RE: Application for Permit BNCR-1101

This submittal contains a response to your letter to us dated August 15, 2013. In this letter you listed technical deficiencies that must be addressed before the permit application for BNCR-1101 can be approved. Below is a listing of the deficiencies followed by our response:

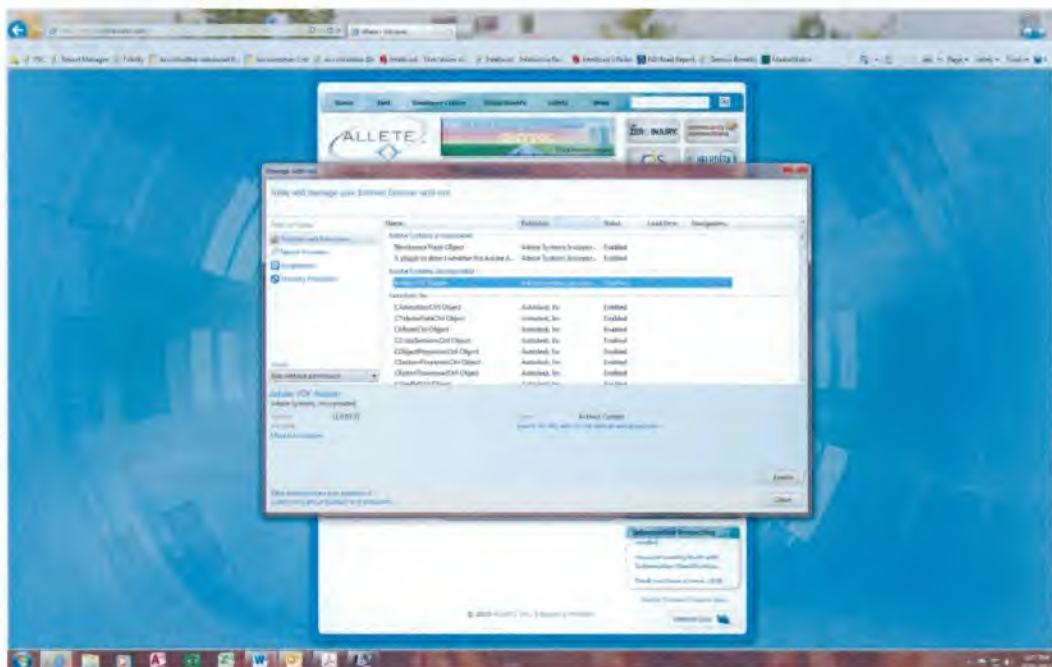
2. Several plates and appendices in the permit are too large to allow one to readily view them in electronic format. This includes Plates 3.4-5, 3.5-1, 3.6-1, 3.6-2 and Appendix 3.5-3. Please revise these plates and appendices so that they can be opened and viewed efficiently. (GAW/ZAT)

We have re-saved the PDFs of the plates listed as Optimized PDFs. This has reduced the opening time for these plates. Currently these plates take 20-30 seconds to open. Also, if your internet explorer is configured so that the PDFs open inside the browser, this will make the documents slower to open. Settings need to be set so that when a link is opened from the electronic permit it is opened in Adobe PDF, not Internet Explorer. To change the settings to have PDFs open in Adobe please do the following: In Internet Explorer, click on the "Tools" menu, select "Manage Add-ons". A window will open and about halfway down the left side click on the tab that states "Currently loaded add-ons". Select "Run without permission". Locate "Adobe PDF Reader" in the list and select it. Right mouse and select "Disable". Please see the example below.
